# FORWARD ACCESS

Our Project Reference No: 202401.1  
Site Address: 73 BULWER STREET MAITLAND NSW  
Site Use: DISABILITY DAY CARE FACILITY  
Client: HOOVER GROUP PTY LTD  
Client Contact: ELLIE TILSE  
Report Date: 16/09/2024  
Report Revision: REV. 1  
Prepared By: JEREMY SODEN  
FORWARD ACCESS PTY LTD  
ABN: 73 654 486 601

#### Doorways, doors and circulation space at doorways

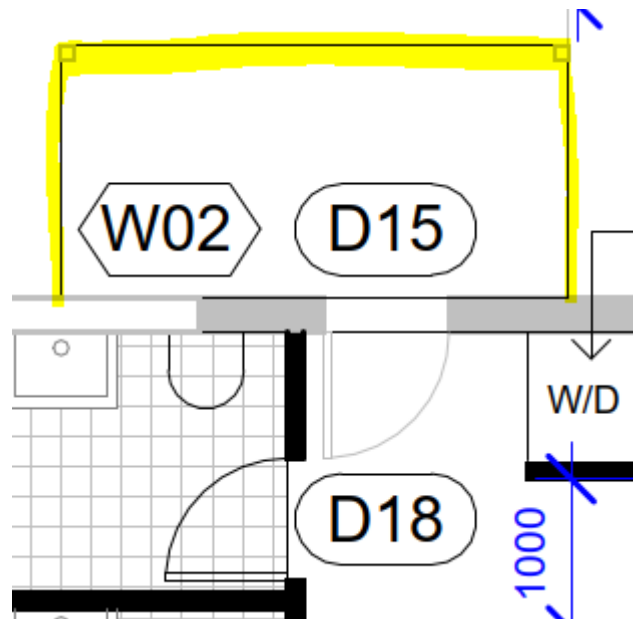
Doorway D14 and D15 are not provided with latch side circulation space in accordance with AS1428.1-2009. Doorway D14 must be provided with a minimum of 510mm latch side circulation space on approach from the corridor towards the doorway. Doorway D15 must be provided with a minimum of 530mm latch side circulation on approach from the corridor towards the doorway. Alternatively, the certifiers must deem these areas as exempt or a performance solution from an access consultant will be required. The applicant has advised the certifier will deem these doorways exempt under BCA Vol 1 2022 Part D4D5.

Doors D13, D14, D18 and D21 will not provide a minimum 850mm clear opening width through the doorways. These doorways could be exempt from the certifier or an access consultant could provide a performance solution for these doorways.

The flooring transition details have not been provided on the plans and cannot be effectively assessed on design documentation. The flooring transitions between flooring transitions must not exceed a 3mm vertical edge or 5mm bevelled/rounded edge.

It appears there may be a step or threshold up to D15. The applicant has advised the certifier will deem this area exempt under BCA Vol 1 2022 Part D4D5.

### From the allotment boundary

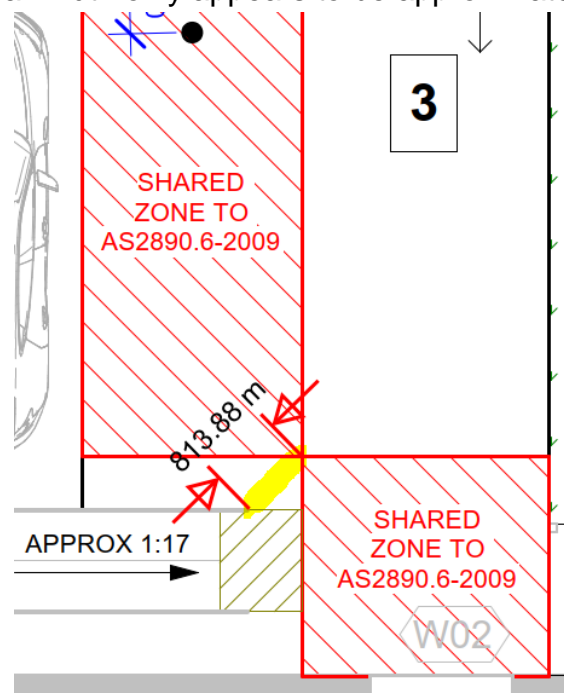
A continuous accessible path of travel complying with AS1428.1-2009 must be provided from the main points of a pedestrian entry allotment boundary to the principal pedestrian entrance of the building required to be accessible.

A plan has not been provided showing the gradients of the continuous accessible path of travel from the main points of a pedestrian entry allotment boundary to the principal pedestrian entrance of the building required to be accessible. Provide a plan showing compliant gradients in accordance with AS1428.1-2009.

A continuous accessible path of travel complying with AS1428.1-2009 must be provided from the accessible car parking areas on the same allotment to an entrance of the building required to be accessible.

Please illustrate a minimum 1000mm clear accessway provided from the side shared zone of the accessible car parking space to the ramp, clear of the dedicated car parking space. The clear width only appears to be approximately 813mm wide.

### Threshold ramps

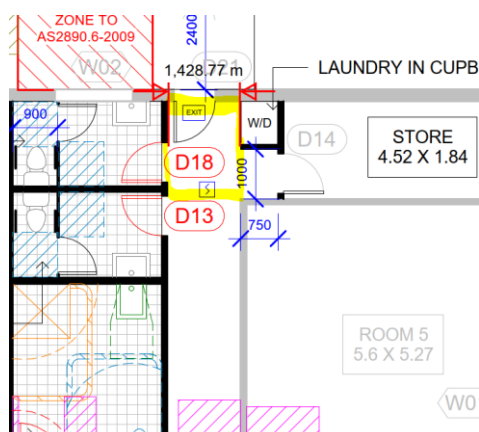
Threshold ramps have not been illustrated on the plans. The threshold ramps can readily be addressed during subsequent stages of development. Alternatively, provide a threshold ramp detail for assessment.

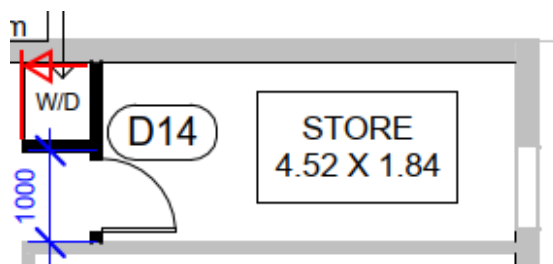
The following areas within this development have been identified as potential exempt areas, subject to certifier's concurrence:

- The 'store' room
